66321B-07

S E R V I C E N O T E

Agilent 66321B DC Power Supply

On faster computers, when programming over GPIB, a random error will occur.

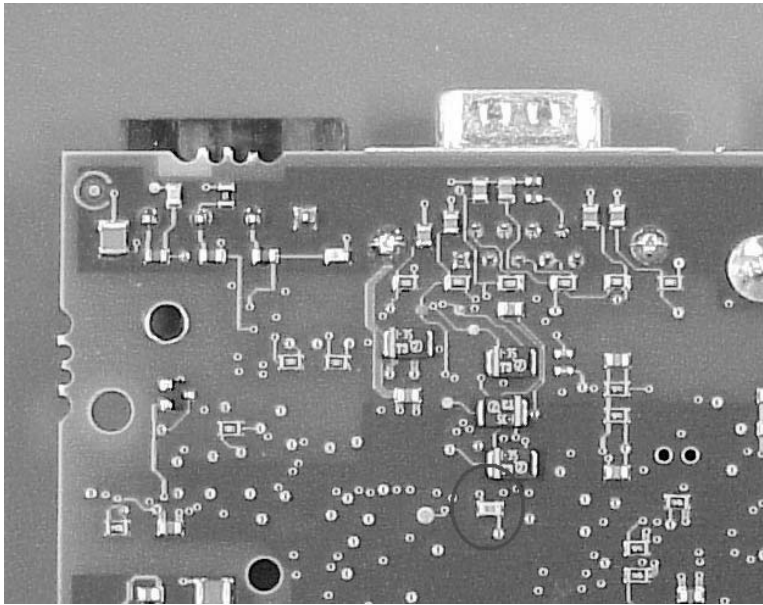
When programming a unit over GPIB, a random error -113 (“Undefined header”) will appear on the unit. This error can be read back via the front panel or over the GPIB bus.

Change resistor R1246 (see picture for location) from 511 Ohms to 100 Ohms (part number 0699-3058). This requires soldering a surface mount component and can be very difficult. This does not require re-calibration.

Replace the entire GPIB assembly (part number 5063-4841) with a newer one that has the 100 Ohm resistor. This will require the unit to be re-calibrated.
